Design Review Board Case #2019-0001
WMATA Building - Block 15A / 2395 Mill Road

Application	General Data	
Project Name: WMATA Office Building – Block 15A Location: 2393, 2395, 2403, 2415, & 2421 Mill Road Applicant: WMATA c/o McGuireWoods LLP	DRB Date:	September 26, 2019
	Site Area:	3.116 acres (135,737 sf)
	Zone:	OCM(100) & UT to CDD#2 & UT
	Proposed Use:	Office Building
	Gross Floor Area:	425,187 SF
<p>Purpose of Application: Final design review of the landscaping and site signage for an approved new 14-story office building with above-grade parking. This is the fourth review of the proposed project.</p>		
<p>Staff Reviewers: Robert M. Kerns, AICP robert.kerns@alexandriava.gov Thomas H. Canfield, AIA tom.canfield@alexandriava.gov Dirk H. Geratz, AICP dirk.geratz@alexandriava.gov Abigail Harwell abigail.harwell@alexandriava.gov</p>		
<p>DRB ACTION, SEPTEMBER 26, 2019: The DRB voted unanimously to approve the proposed landscaping and signage, with the equipment enclosure to have a dark metal façade that matches the building and per drawings that the applicant presented. Direction was given to provide as much landscaping space around the enclosure as possible to allow for landscapi

Image 2: Final Site Plan Drawings – Transformer Locations and Elevations (Sheet A203)

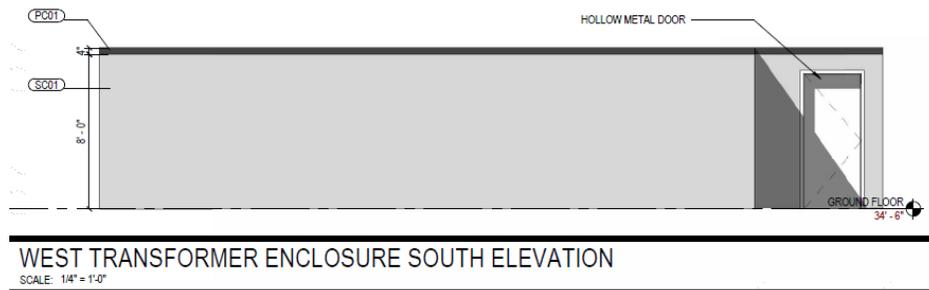
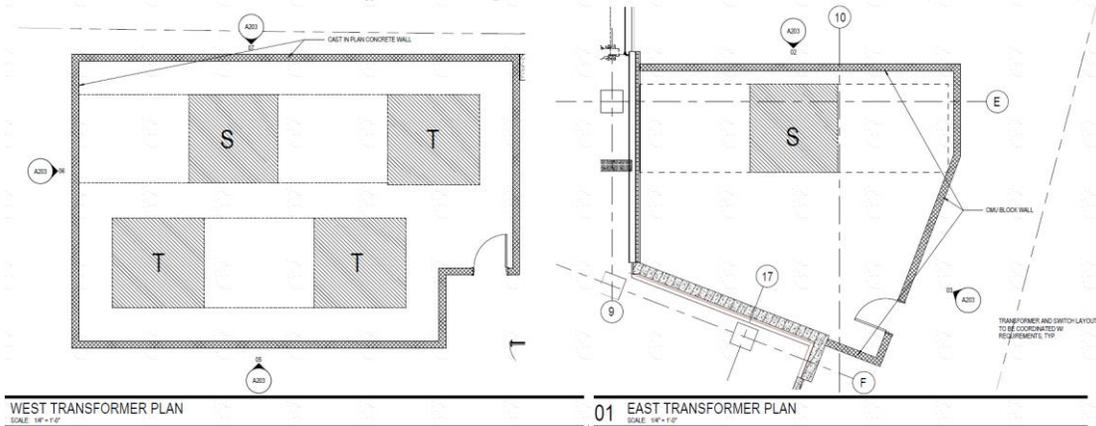
There are two transformer areas indicated on the plans: one area on the west side of the building, at the end of the main entrance driveway, and a second area on the east side of the building, adjacent to the loading bays. More information has been provided regarding these enclosures, including design and material solutions. It should be noted that there is a discrepancy between the plans submitted for DRB review and the plans submitted to Staff for Final Site Plan Review, as shown on Exhibit A. The wall surrounding the equipment is to measure 8'-4" tall with hollow metal doors. The material is proposed as a stucco finish, in a color to match the precast of the building. No landscape screening is proposed for either enclosure due to spacing constraints. Staff had asked the applicant to provide additional vegetative screening to soften the appearance of the enclosure walls, with either vines or additional greenery. The applicant has declined to provide this, citing shade concerns and security requirements.

In discussing these enclosures, it should be noted that, while the enclosure on the east side of the building will be minimally visible, the one on the west, sitting as it does directly on axis with the pedestrian and vehicular entry, is visually extremely prominent. At 30 by 40 feet in size, the enclosure is essentially a small building. Since the previous submission, it has been moved to the east, resulting in an unattractive and virtually unmaintainable gap of approximately 18 inches between it and the exterior wall of the office building. A notch has also been cut out of the southeast corner of the enclosure for an access door, which faces the main entry to the site and further draws attention to the uncomfortable juxtaposition of building and transformer enclosure.

While staff would strongly prefer a solution that relocated the west transformer yard to the east side of the building (potentially in lieu of the six parking spaces shown near the garage entrance), applicant has explained that existing easements preclude that option.

Given the above, staff feels that the best solution for mitigating the impact of the west transformer enclosure is to treat it as an extension of the office building. Staff recommends using the two adjacent building materials to form the south and west walls of this enclosure – specifically, the stone base (which is approximately four feet tall at this location) combined with the office building façade louver system for the top half of the wall. For the access doors to the enclosure, staff recommends locating them in the middle of the south or west façades. This treatment effectively eliminates the east side of the enclosure, and leaves a single wall facing the rail corridor that could be treated more simply. Staff has provided an exhibit illustrating this concept, simply using elements of the proposed building façade (EXHIBIT B).
